CITY OF SAN ANTONIO

PROJECT: SEELING CHANNEL IMPROVEMENTS - PHASE I

ADDENDUM NO. 4

DATE: August 29, 2012

PROJECT NO. 1 S10063 DATE: JULY 23, 2012
DRAWN BY: CMH, GR DSGN. BY: MWP CHKD. BY: JZ, MWP SHEET NO. LS 2.4

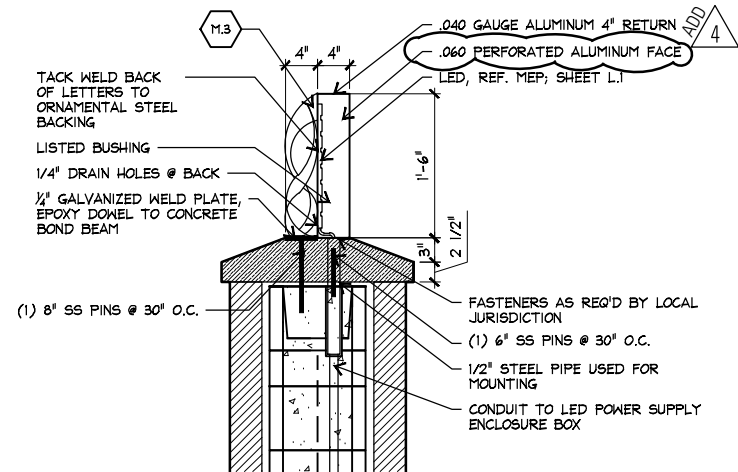
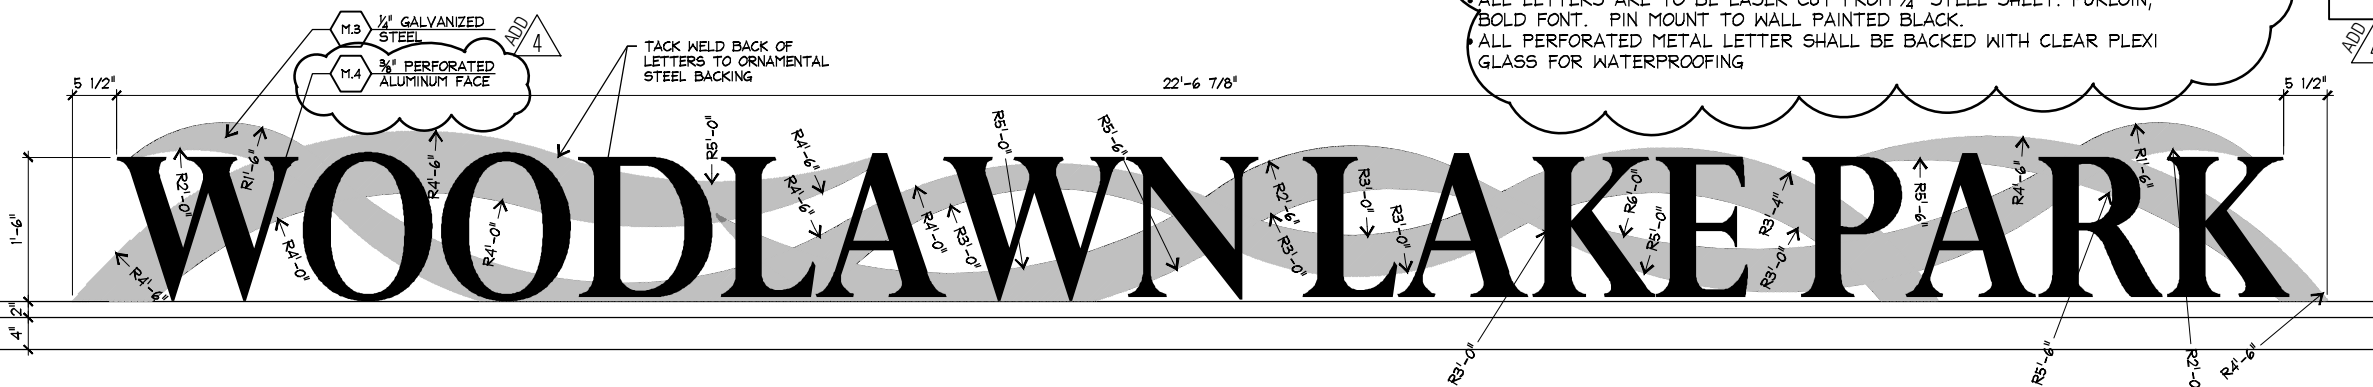
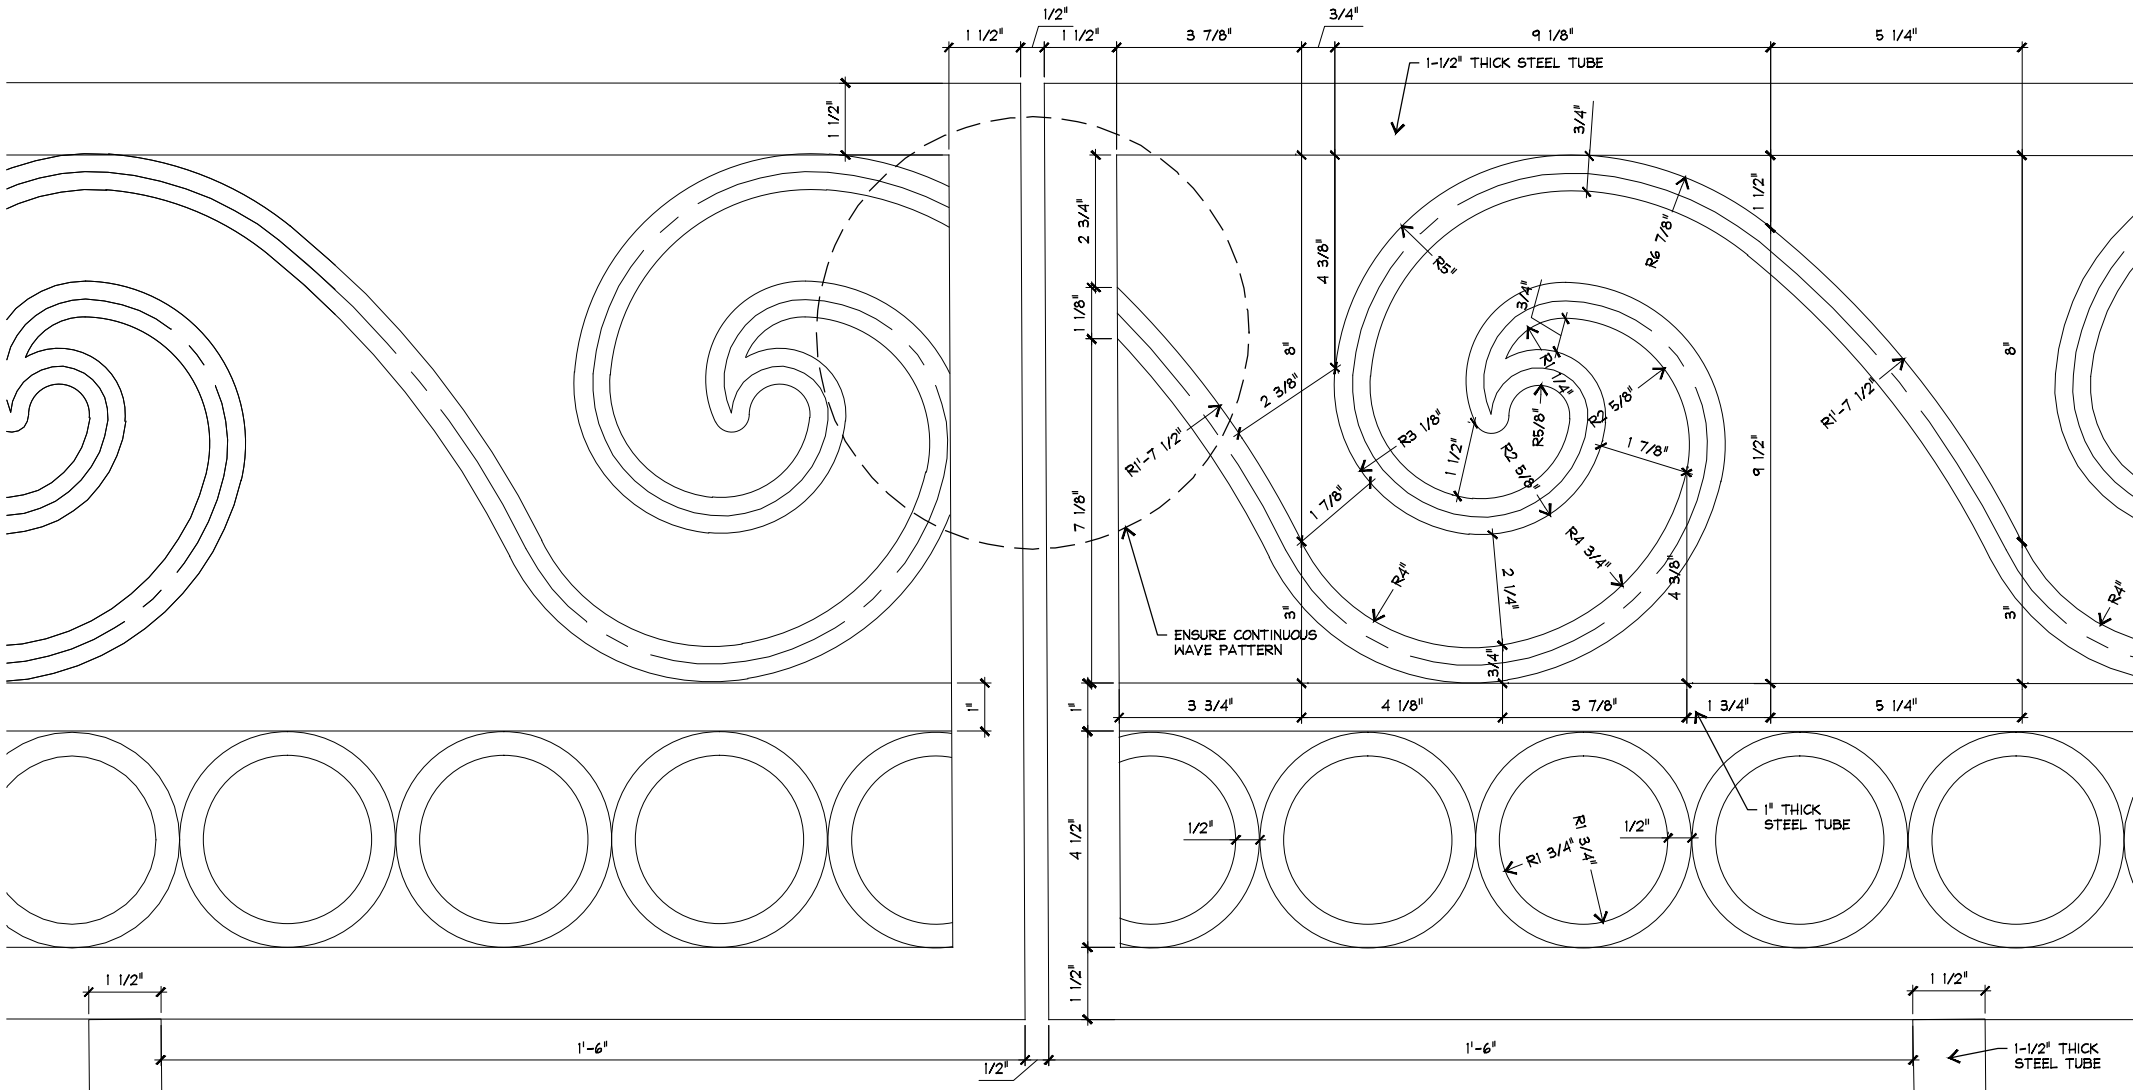
- A12.1 The City would not object to this approach provided erosion and siltation are addressed appropriately.
- Q13. *Page 405 – Aluminum letters call for a corrugated face with a 4" return. Can we get a larger detail and is the return and the corrugated face a continuous weld?*

- A13. Aluminum letters are to be perforated and not corrugated. The letters do not need to be a continuous weld, but there needs to be some sort of waterproofing protection. Photos of an example perforated sign face are provided below. On past projects they have been produced by sign manufacturers. Sheet LP2.4 is updated in this Addendum 4.

BID SUBMITTAL PROJECT NO. 60184822 DATE: JULY 2012
DRWN. BY: M.G. DESGN. BY: T.W. CHKD. BY: CC SHEET NO. 6 OF 15

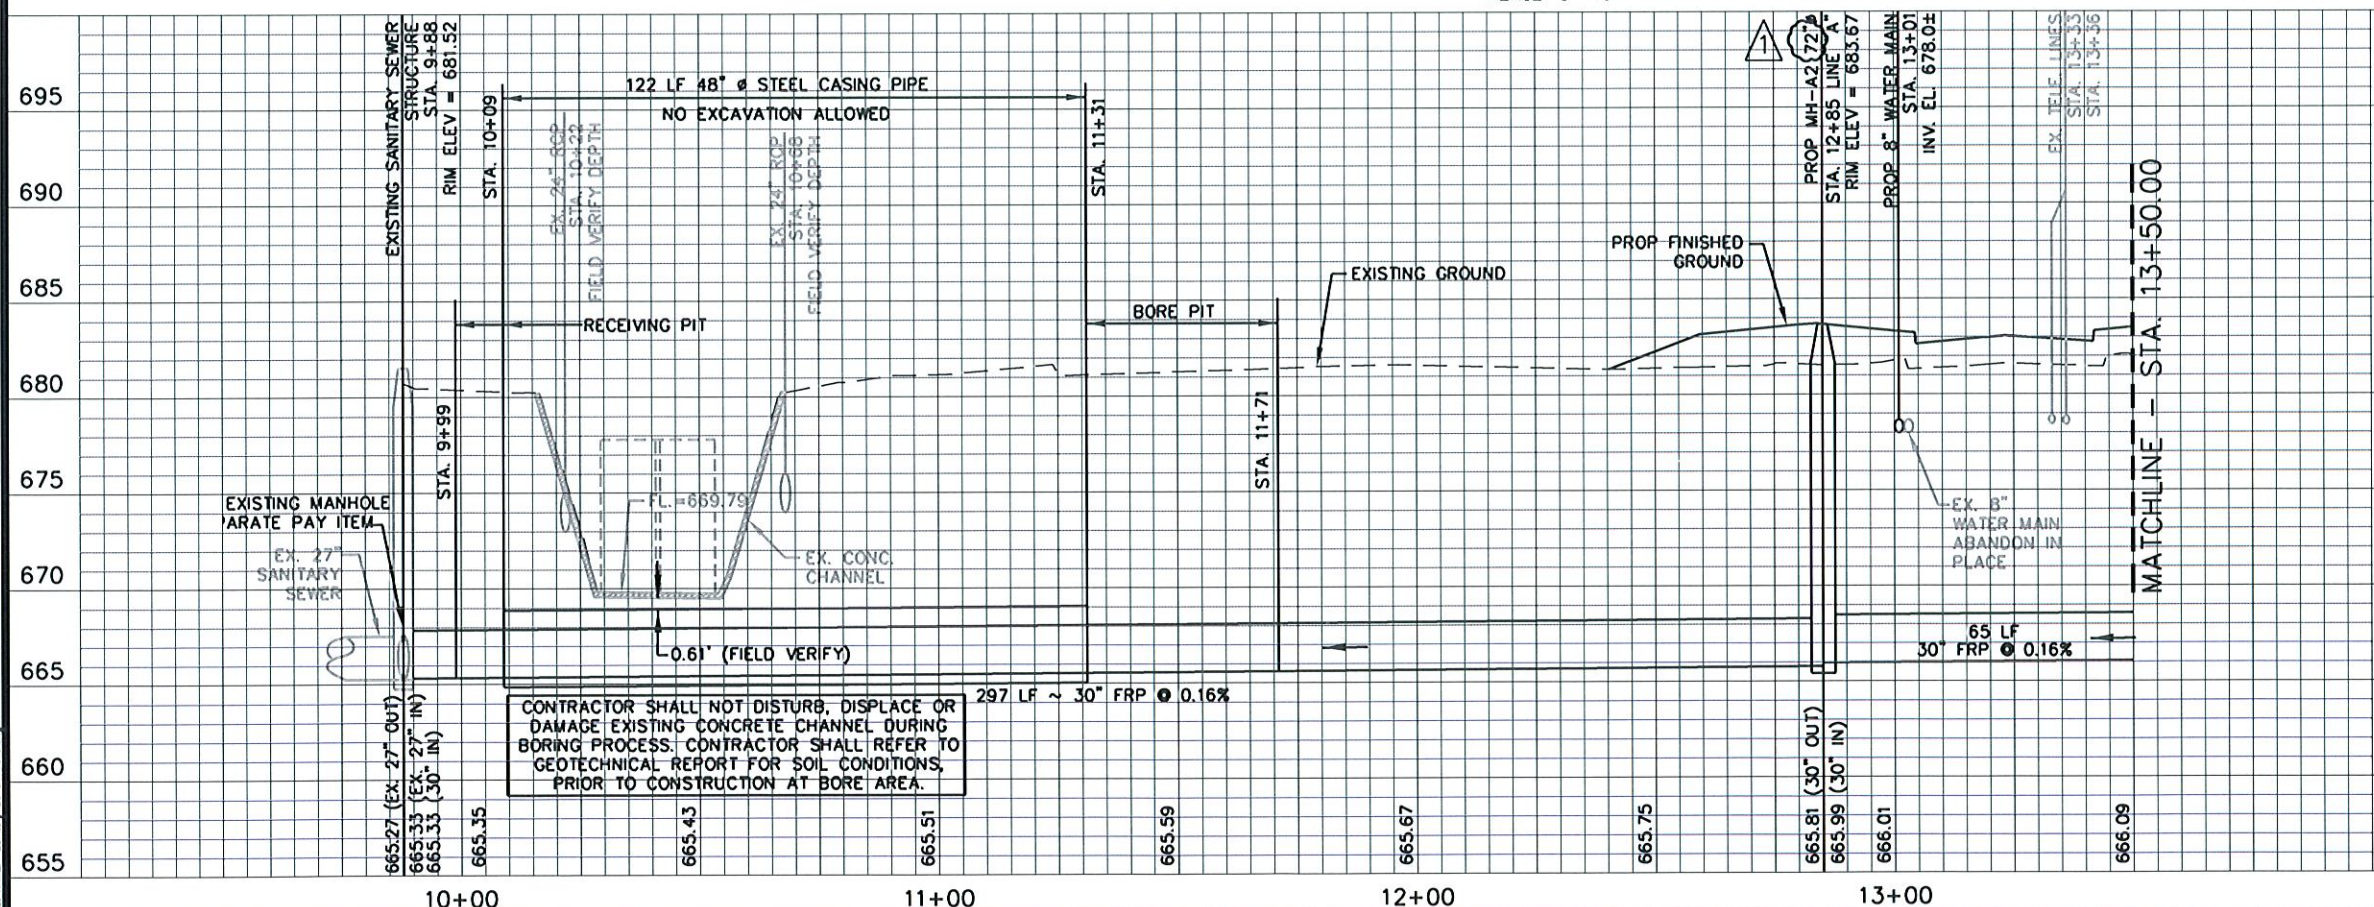
- Q1. *Can we get a detail of what SAWS is asking for on the 60", 72", and 90" manhole structures?*
A1. Addendum 1 revised bid item 850 – Sanitary Sewer Structure from 90" to 96". SAWS Standard Specification for Construction Item No. 850 includes a detail for a Sanitary Sewer Structure for 72" and 96". Addendum 4 revises the SAWS Plans to remove the 60" sanitary sewer structures and replace them with 72" sanitary sewer structures.

NO	DATE	DESCRIPTION	DWGCHK
1	8/23/12	REVISED SANITARY SEWER STRUCTURE FROM 60" TO 72"
